Generic Environmental Impact Statement for License Renewal of Nuclear Plants

Supplement 10, Second Renewal

Regarding Subsequent License Renewal for Peach Bottom Atomic Power Station Units 2 and 3

Final Report

Figure 1-1 Environmental Review Process

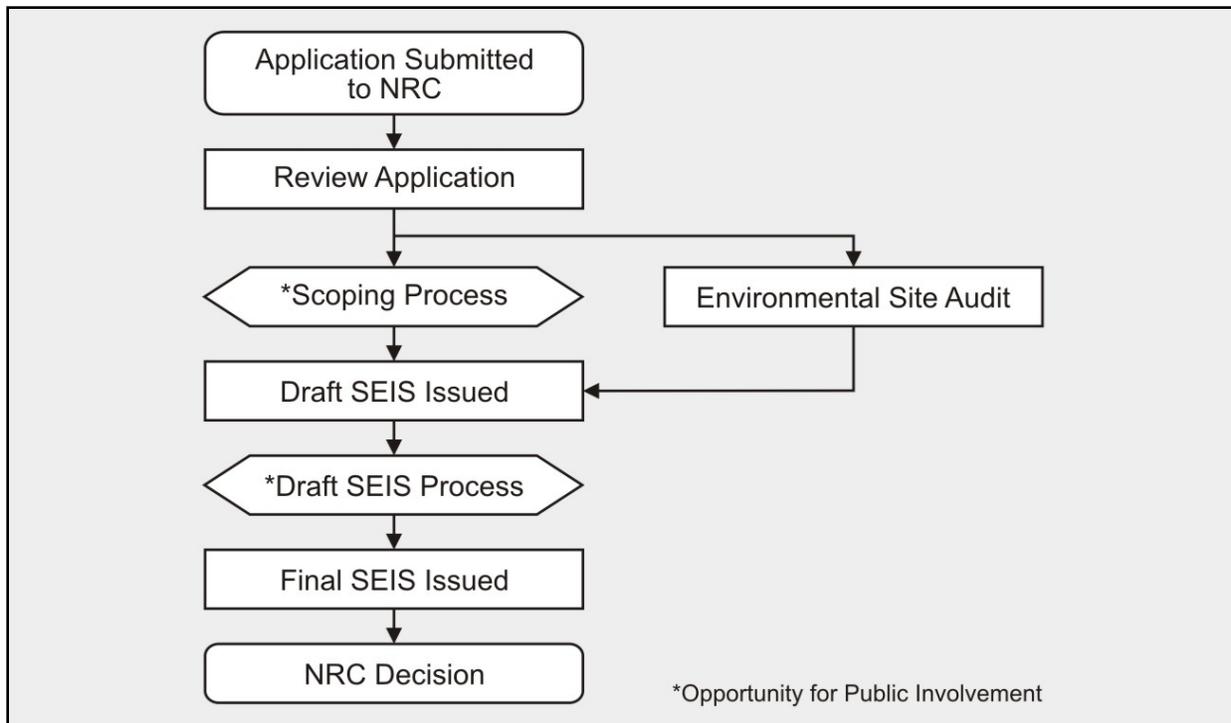
D-141	120	Consider clarifying that the NRC Decision on subsequent license renewal is not based only on the final SEIS by adding a text box labeled “NRC Safety Review Final Results” to Figure 1-1 with an arrow showing this activity entering the flow independently and immediately prior to the “NRC Decision” box.	<i>The NRC staff determined that no changes were necessary to the figure. The figure title and surrounding text indicate that the figure only addresses the environmental review.</i>
D-142	121	Check orientation of North arrows in Figure 3-3. The North arrow in the “blow-up” of the plant site (upper RH corner in Figure 3-3) has a different orientation than the North arrow in the lower RH corner in Figure 3-3. The North arrow in the lower RH corner appears to be most accurate (i.e., in the vicinity of the Peach Bottom plant site, the Susquehanna River flows from NW to SE, rather than from N to S). The North arrow in Figure 2.2-1 in the Peach Bottom SLR ER (from which the “blow-up” was developed) was also erroneous. See also Figure 3-6 (p. 3-34 in this DSEIS), on which the North arrow appears to be correctly oriented.	<i>The NRC staff revised the north-south orientation in the insert</i>

Figure 3-4 Location of the Principal Components of the Cooling-Water Loop

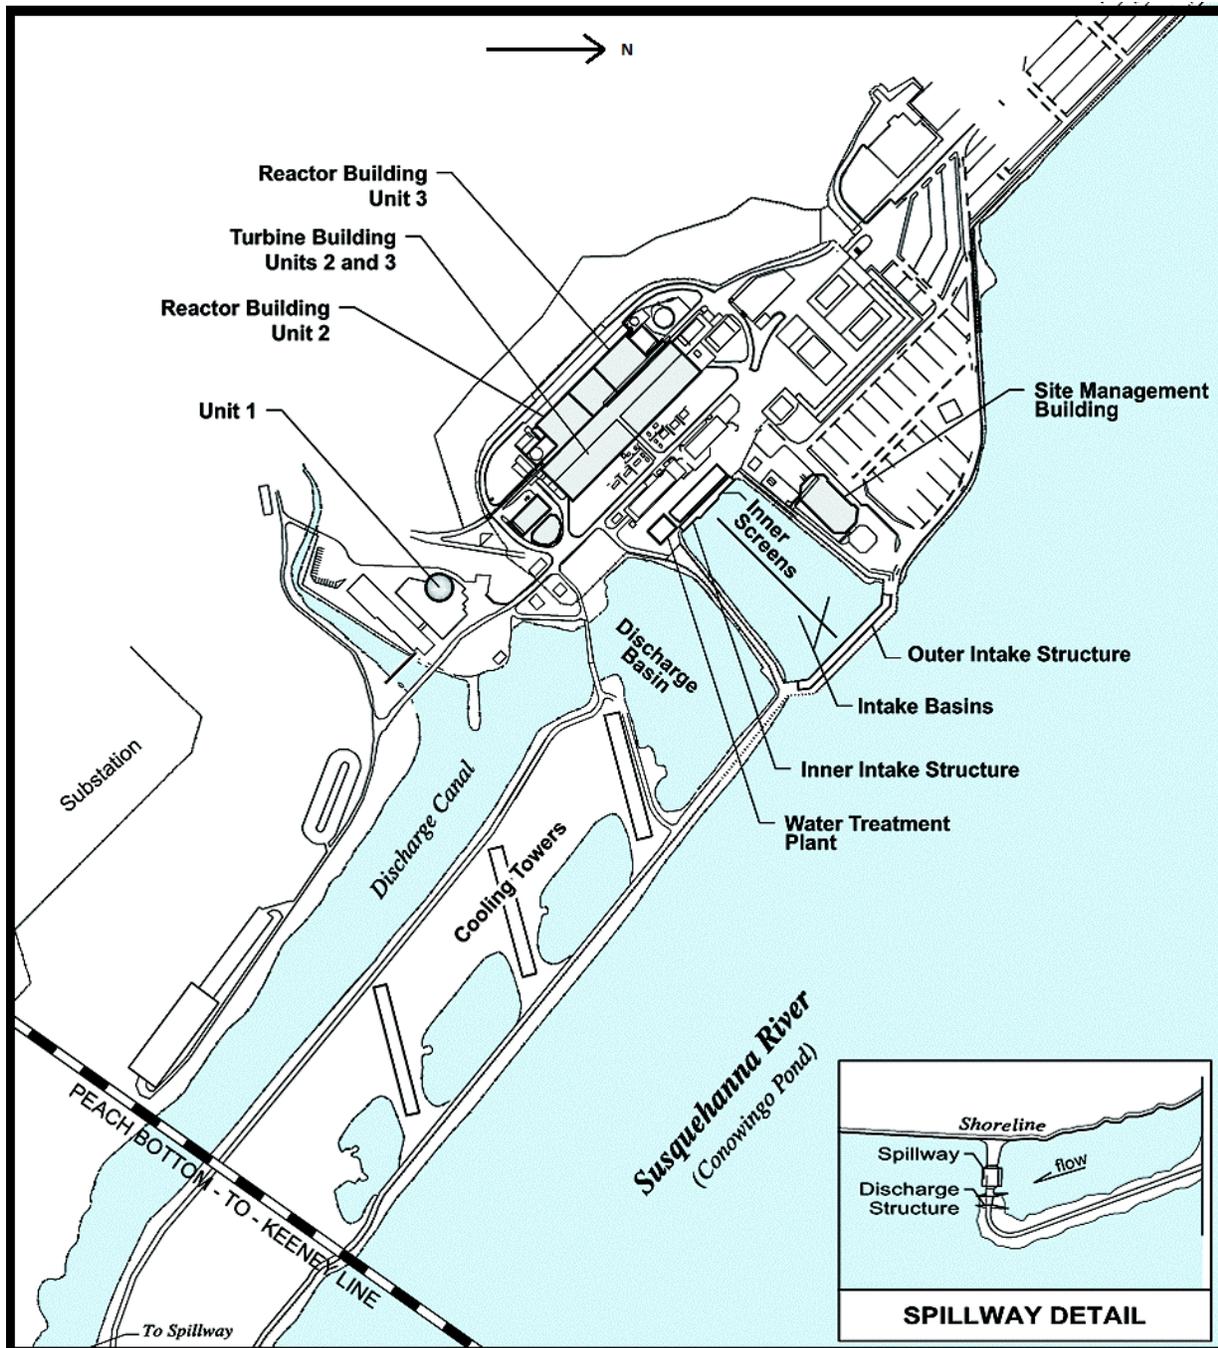
D-143	122	Same comment as for Figure 3-3. The North arrow for Figure 3-4 is not accurately oriented.	<i>The NRC staff revised the north-south orientation in the figure.</i>
D-144	123	In Table 3-1 on page 3-19, based on any changes made in line 7 on page 3-19, make conforming changes to the Table 3-1 column labeled “Pollutant.”	<i>The NRC staff made the recommended edits in Comment D-62. Therefore no changes were needed.</i>

Figure 4-2 Relative Percentage of Entrained Fish by Species

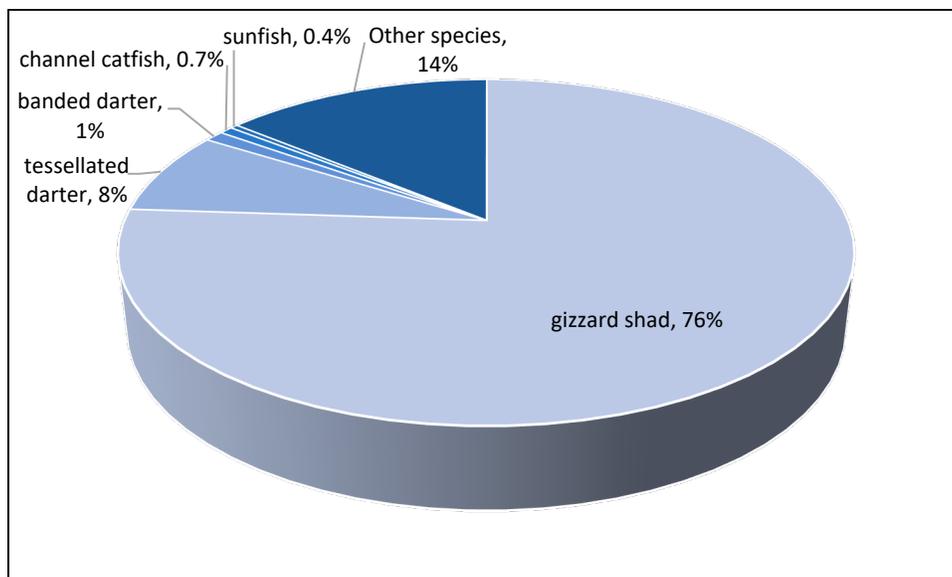
Comment D-9 (Exelon 9): Figure 4-2 in line 1 on page 4-43 is labeled in line 3 as "*Relative Percentage of Entrained Fish by Species*," and "URS and NAI 2008" is cited in line 2 on page 4-43 as its data source. Exelon Generation believes this citation to be erroneous because URS and NAI 2008 (ADAMS Accession No. ML19007A326) addresses only impingement mortality characterization data and contains no entrainment data.

Accordingly, a corrected citation should be provided for the source of the data depicted in Figure 4-2 on page 4-43.

Response: *This comment points out an incorrect citation. The NRC staff corrected the data source for Figure 4-2 by changing it to "NAI 2013b," which is the report that describes the 2012 entrainment characterization study conducted at Peach Bottom.*
